Access Compliance Report

Public Rights-of-Way

Intersection ID: 47572	Main Street: HERMSLEY_RD	Cross Street: BARRANDS_LN	Location:	SW
ADA ID: 4376DC024983	Ramp Type: PerpDiag	Initial Pass/Fail: Fail	Overall Compliance: No	Severity Score: 10

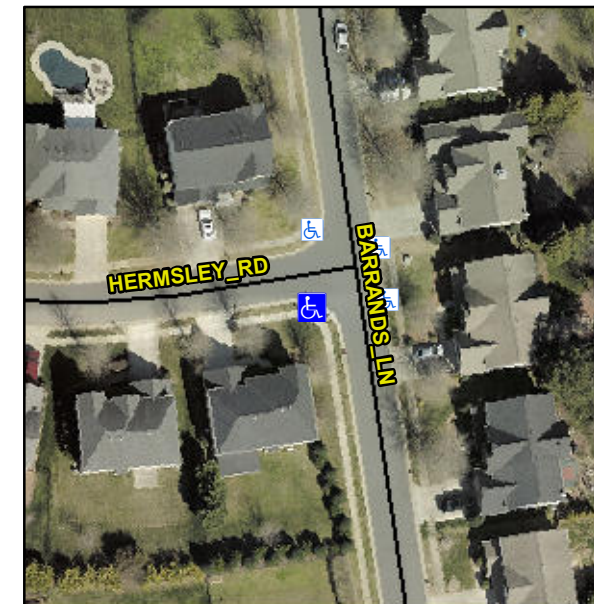
Not Found, R304.5.1, R304.5.3

Compliance	Description	Data	Compliance	Description	Data
N/A	Ramp Length (in)	49.0	Yes	Ramp Slope (%)	5.2
No	Ramp Width (in)	44.0	No	Ramp XSlope (%)	4.3
N/A	Flare Type LT	N/A	N/A	Flare Type RT	N/A
N/A	Flare Slope LT (%)	N/A	N/A	Flare Slope RT (%)	N/A
N/A	Flare Traversable LT?	N/A	N/A	Flare Traversable RT?	N/A
N/A	Landing Length (in)	N/A	N/A	DWS Provided?	N/A
N/A	Landing Width (in)	N/A	N/A	DWS Contrast?	N/A
N/A	Landing Slope (%)	N/A	N/A	DWS Length (in)	N/A
N/A	Landing X Slope (%)	N/A	N/A	DWS Full Width?	N/A
N/A	Landing Curb? (Y/N)	N/A	N/A	DWS Offset (in)	N/A
N/A	Shared Landing?	N/A			
N/A	Gutter Ponding?	N/A	N/A	Gutter Slope (%)	N/A
N/A	Gutter Lip Ht (in)	N/A	N/A	Gutter X Slope (%)	N/A
N/A	Painted X Walk1?	No	N/A	Painted X Walk2?	No
	X Walk 1 Direction	To E		X Walk 2 Direction	To N
N/A	X Walk 1 Width (in)	N/A	N/A	X Walk 2 Width (in)	N/A
	X Walk 1 Slope (%)	3.2		X Walk 2 Slope (%)	2.6
	X Walk 1 X Slope (%)	2.8		X Walk 2 X Slope (%)	3.3

Remove & Replace Curb Ramp With Two New Directional Ramps or Equivalent.
